ARCHITECTURAL ACOUSTICS

DAYTON PRIMARY SCHOOL - DD REPORT

23rd April 2021

PROJECT: Dayton PS - Acoustics DD Report **PROJ No:** 21-004

GA FLOOR PLANS

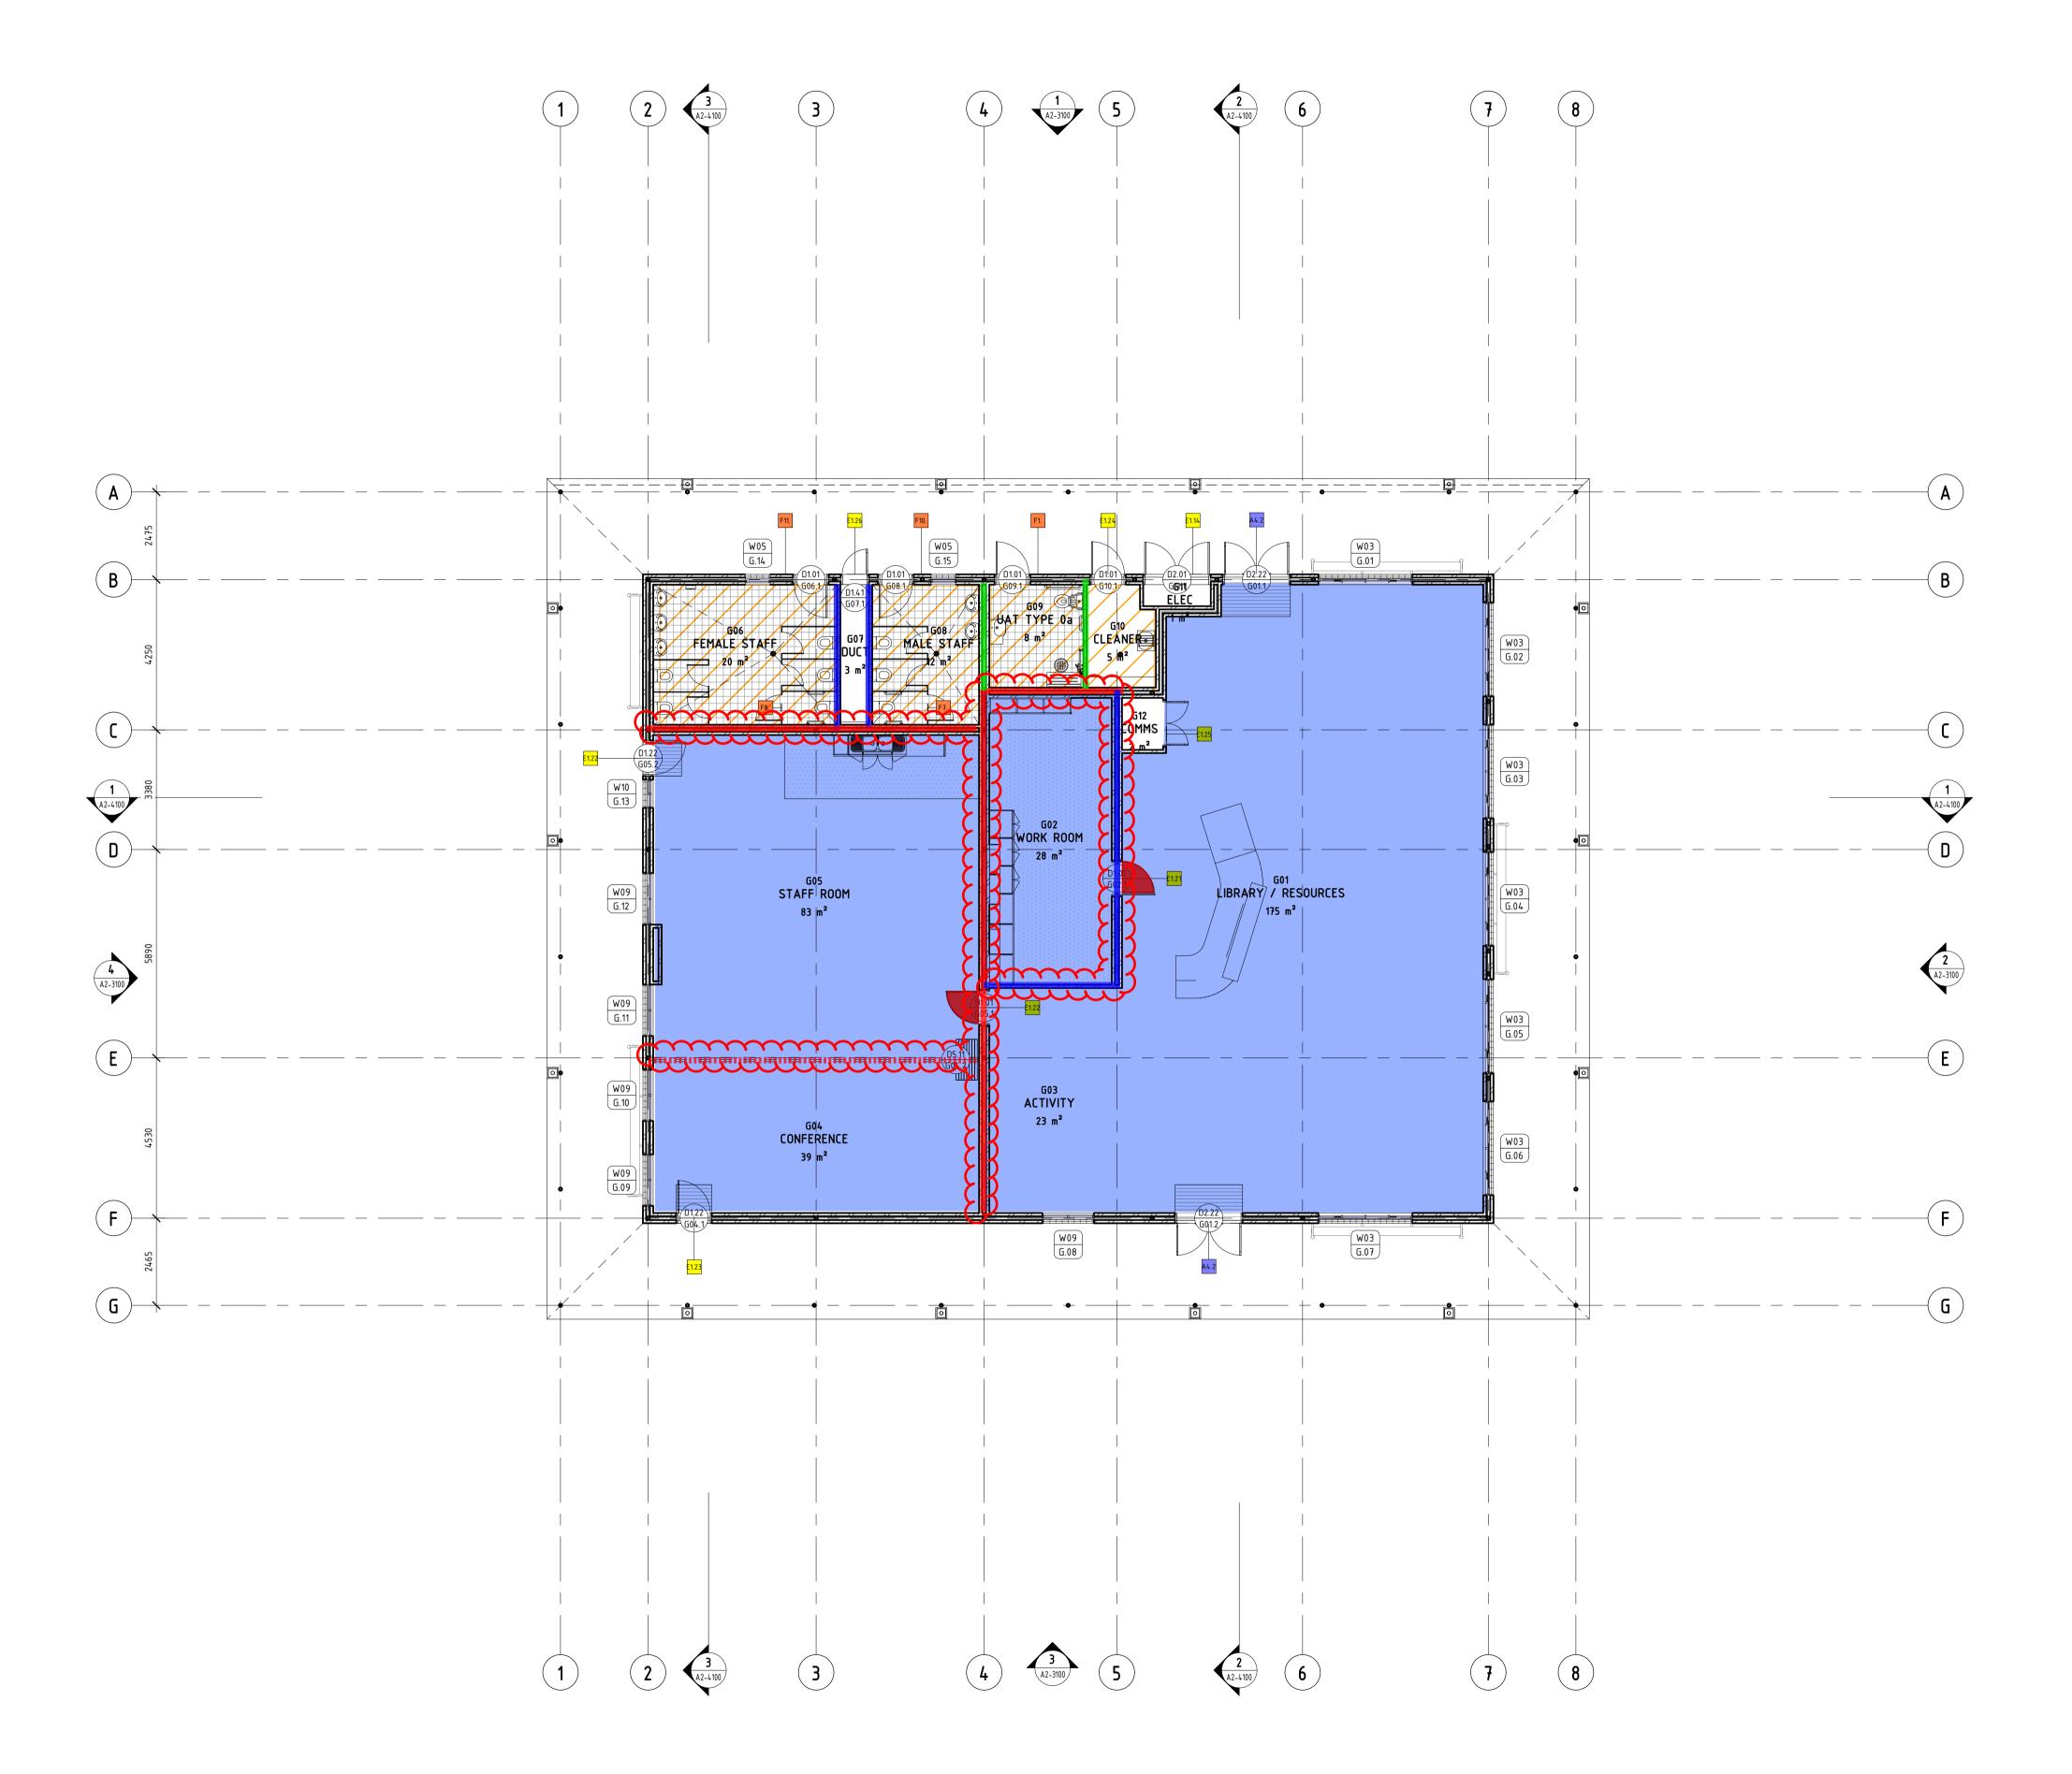
Full height walls are compulsory around spaces that contain perforated ceilings, given that perforated ceilings do not act as a barrier to noise transmission. The required full height walls are clouded in red on the attached plans. It is critical that an air-tight seal is achieved where the walls meet the underside of the roof sheeting / floor slab above:

The locations where it is recommended that acoustically sealed solid core or glazed doors be implemented are indicated on the attached marked-up plans (doors coloured in solid red).

Acoustically absorbent ceilings are required for reverberation control in all multiple occupancy spaces and are annotated in blue on the attached marked-up floor plans. To be effective, at least 80% of the area over each room must be acoustically absorbent, allowing for some flush perimeter borders / bulkheads etc. if required. These ceilings must be specified to achieve a Noise Reduction Co-efficient of NRC 0.75 or better. For schools this is typically achieved by use of perforated metal strip ceilings to entire ceiling area, without closer strips. Examples of perforated metal strip systems include:
